**CERTIFICATE OF APPROPRIATENESS**

**RE: Application Number 21-7157; 1466 Seminole; Indian Village Historic District**

Re: **1466 Seminole Street- Single Family Residence**  
Indian Village Historic District

Re: **1466 Seminole Street- Single Family Residence**  
Indian Village Historic District

**ENLARGED FRONT WALK WEST ELEVATION AND SITE SECTION**

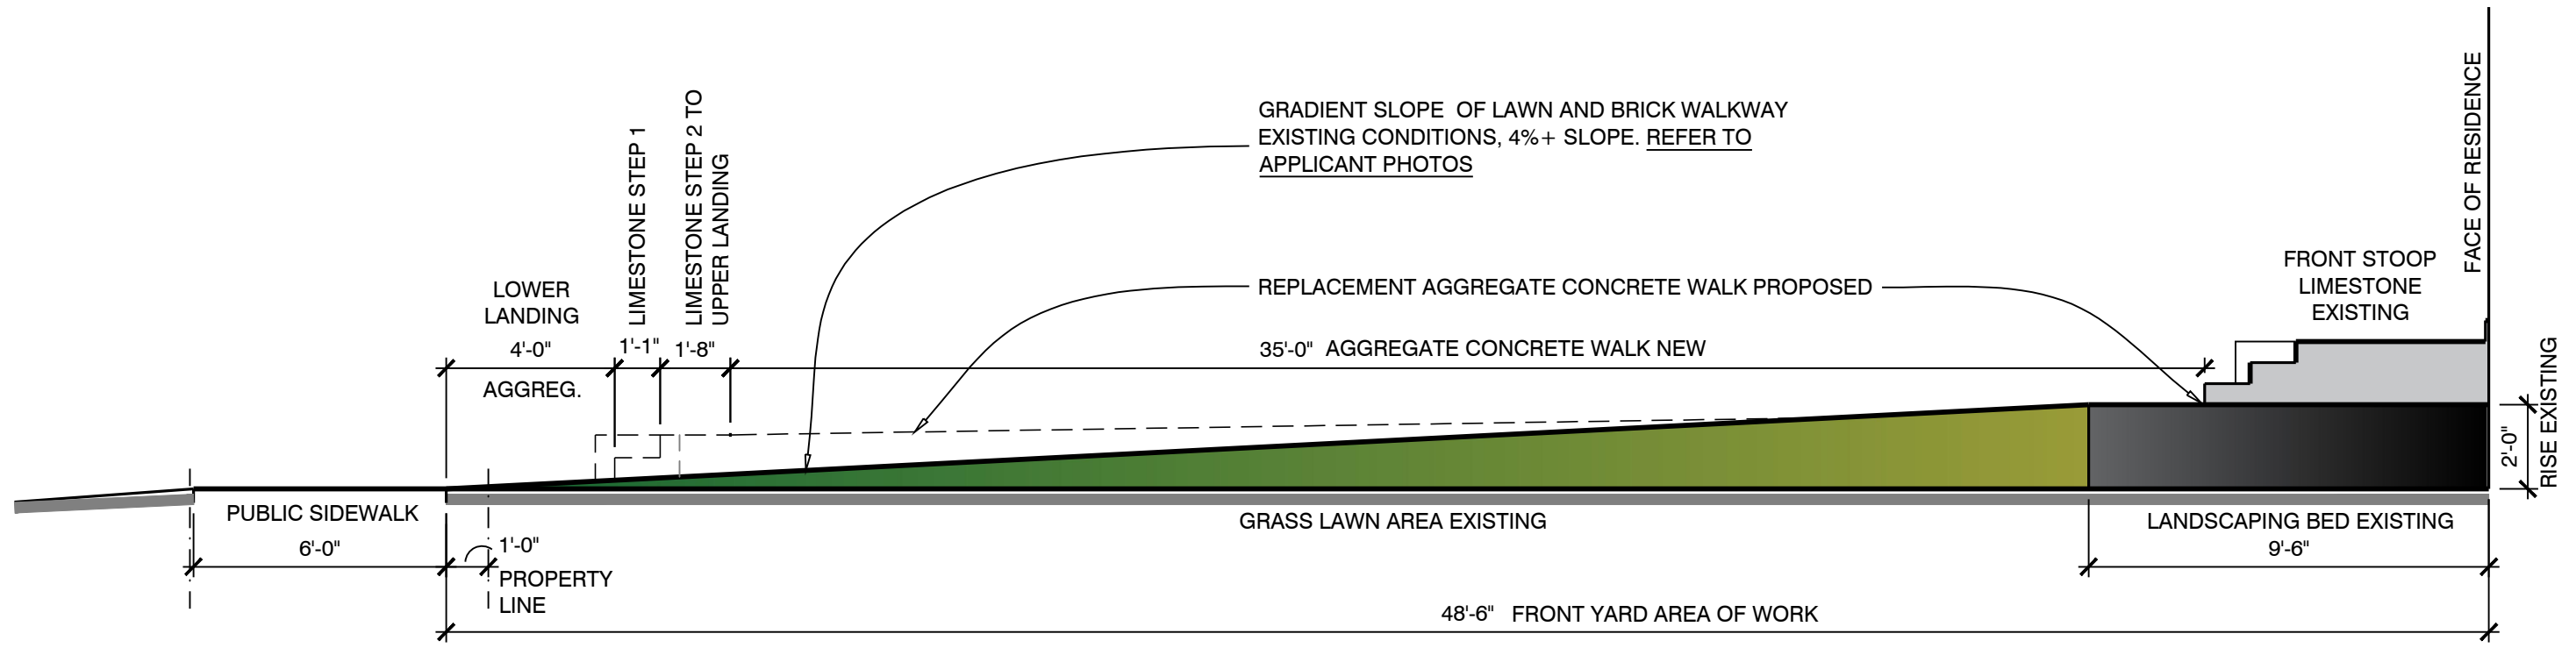
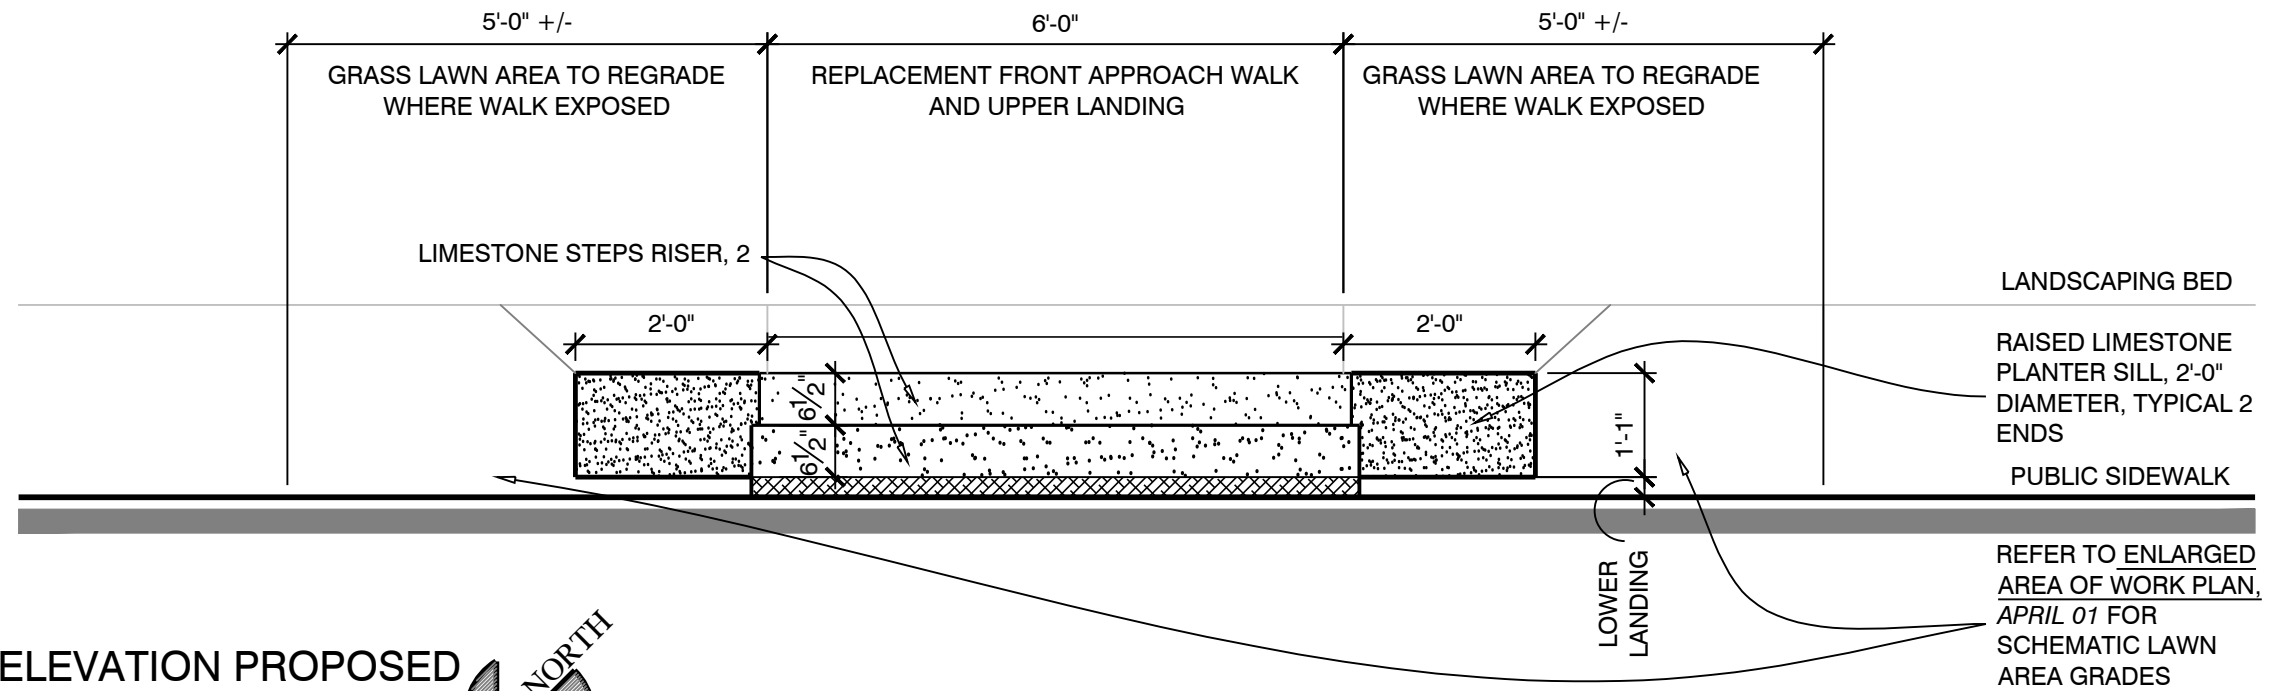
- *Do you have a detail on the proposed step(s) with dimensions and an elevation? We would like to better understand what is the feature, its materials, dimensions both in plan and elevation(s).*

I do not have a detail prepared at this time for the HDC package. I would be happy to accommodate following approval of the Commission, with the Staff report suggestion of "Permit set be reviewed prior to final approval" as a condition. Plan dimensions have been provided upon Sheet A-1, better viewed upon the color **Enlarged Area of Work plan**. *Each step will be 6" to 7" high maximum. The material of the upper step, planter sills and the bottom step are proposed limestone, to match the front stoop existing.* (Photos #5 and 6 in material and massing). **Risers will be linear and not curved.** The aggregate walk will be between the upper limestone tread/landing and existing steps, **and** lower proposed limestone step to the public sidewalk. The aggregate walk is proposed again within the right-of-way, from the public sidewalk to the street curb. Please reference the enlarged plan notes and dimensions updated.
